ADDENDUM NO. 3
STP-3100 (521)
CITY PROJECT NO. 32124
WATER STREET AT LOHMAN'S LANDING
PUBLIC WORKS
April 25, 2014

**Subject: STP-3100 (521), Project No. 32124 – Water Street at Lohman’s Landing
Revised & Additional Job Special Provision and Question & Answers**

Water Street at Lohman's Landing
 MODOT No. STP-3100 (521)
 City of Jefferson No. 32124

Stormwater Design

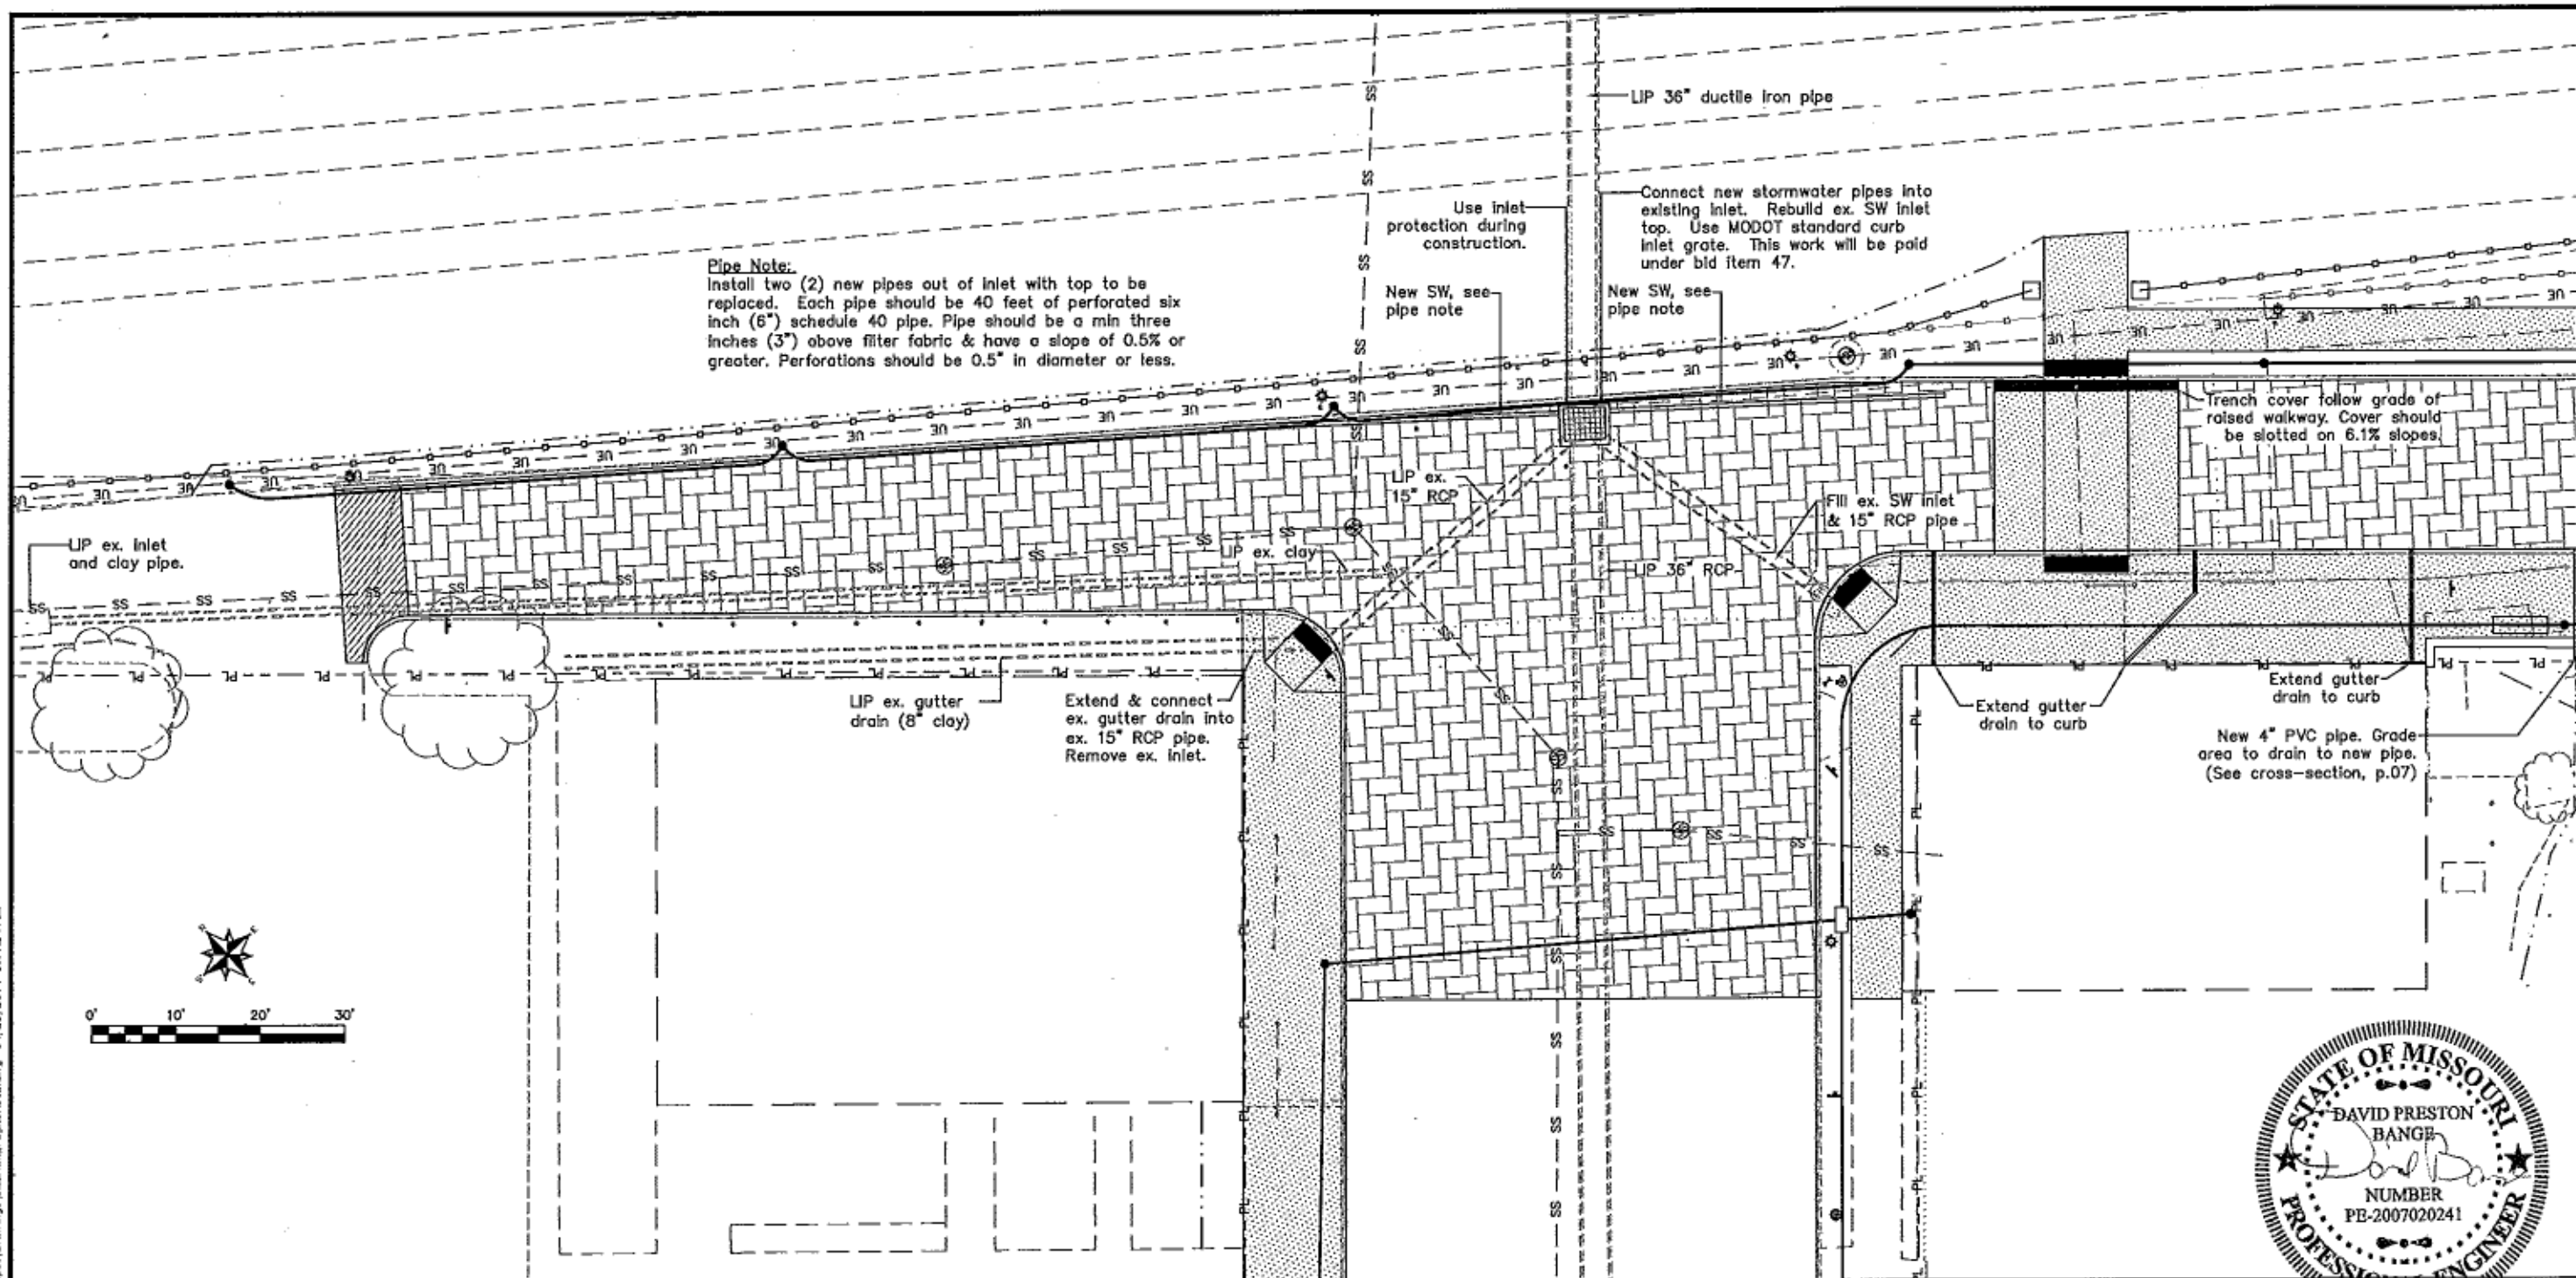
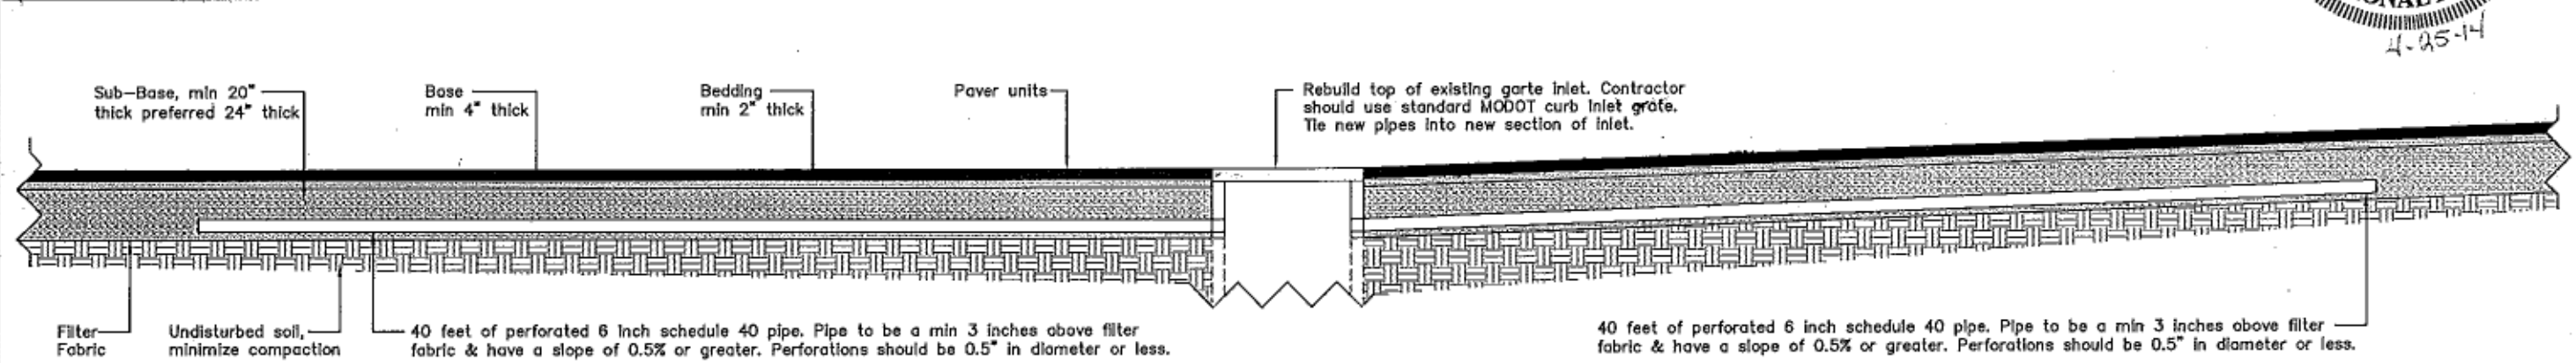
1. Included with this addendum is a stormwater design page. This page includes all revisions to the stormwater design for the project. Any conflicting stormwater shown or noted on other pages should be disregarded.
2. Included with this addendum is a revised bid form dated April 25, 2014. This bid form should be submitted with your bid.
3. Included with this addendum are revised and additional job special provision, and additional question and answers.
